***In the Drawings***

**REMARKS*****In the Drawings***

FIG. 1

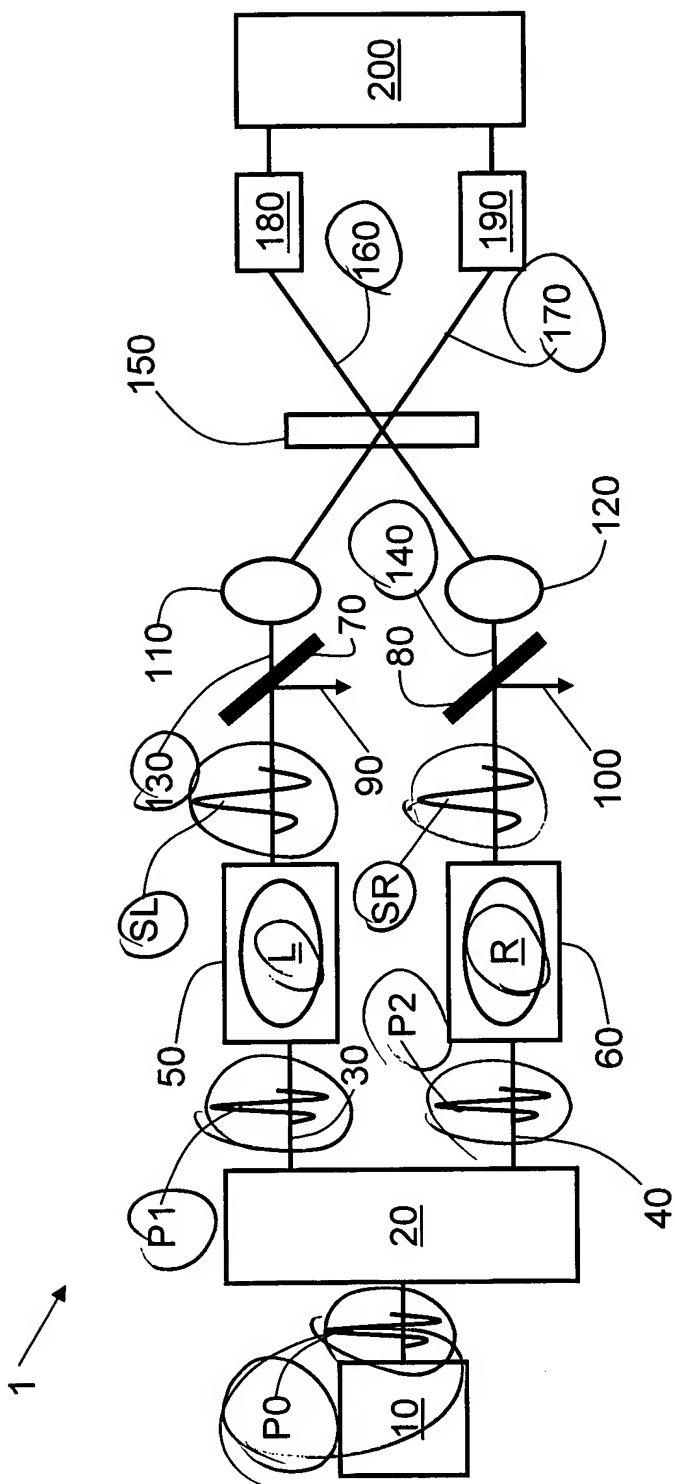
FIGS. 1 through 4 have been amended to include more details of the apparatus as described in the specification and in the claims. In particular, FIG. 1 has been amended to include optical pulses P0, P1 and P2 and Stokes light pulses SL and SR. Also, the atomic ensembles L and R are now shown more clearly as being contained in cells 50 and 60, respectively. Similar changes have been made to FIGS. 2-4, along with the addition of electrical signals S280 and S281 (FIG. 2), and S490 (FIG. 4).
